**November 1, 2019**  
**BOARD OF COUNTY COMMISSIONERS**  
**ORANGE COUNTY, FLORIDA**  
**ADDENDUM NO. 4 / IFB Y20-720-RM**  
**ORANGE COUNTY SOLID WASTE ADMINISTRATION BUILDING ROOF REPLACEMENT**  
**BID OPENING DATE: November 12, 2019**

Photo 2 – 4" Insulation Core Sample at Upper Roof Area

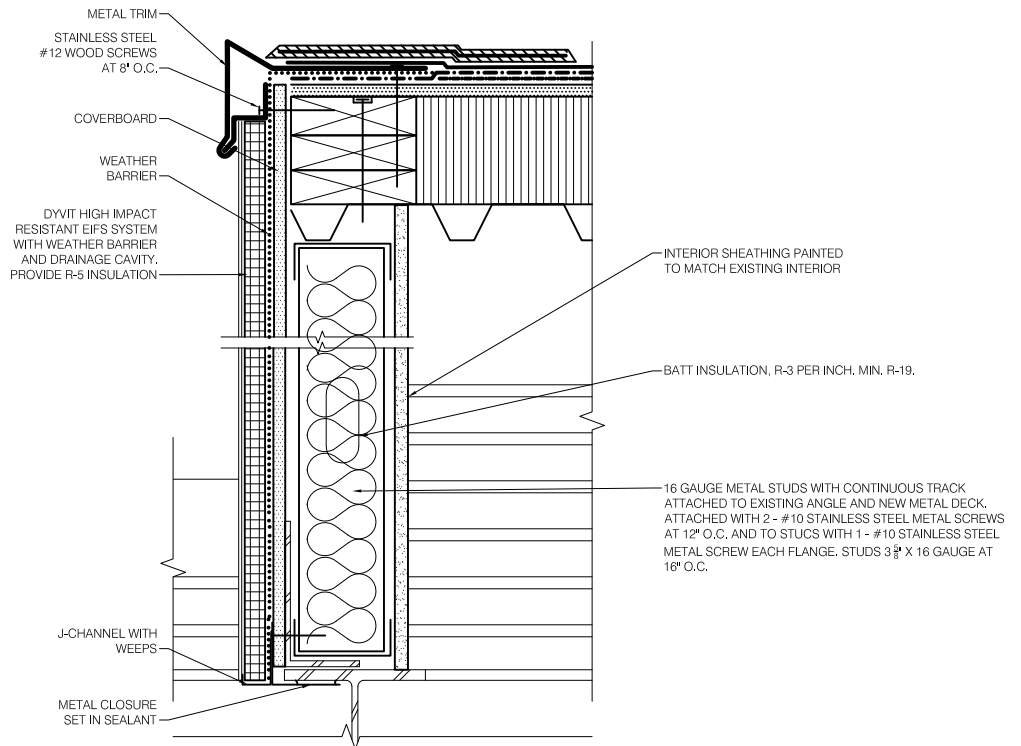
2. Is it possible to obtain the core sample information, including pictures and locations of samples.

**RESPONSE:** The existing roof assembly varies at the canopy, above occupied office space and the unconditioned garage. The canopy has 2” of Styrofoam insulation, occupied office space has 6” and unconditioned garage has 4”. The roof assembly is metal deck with Styrofoam insulation (varies), 5/8” Coverboard, Single-ply membrane, ½” Coverboard and 2-ply Mod Bit. Photo 1 and Photos 2 are attached showing the cores above the garage and office.
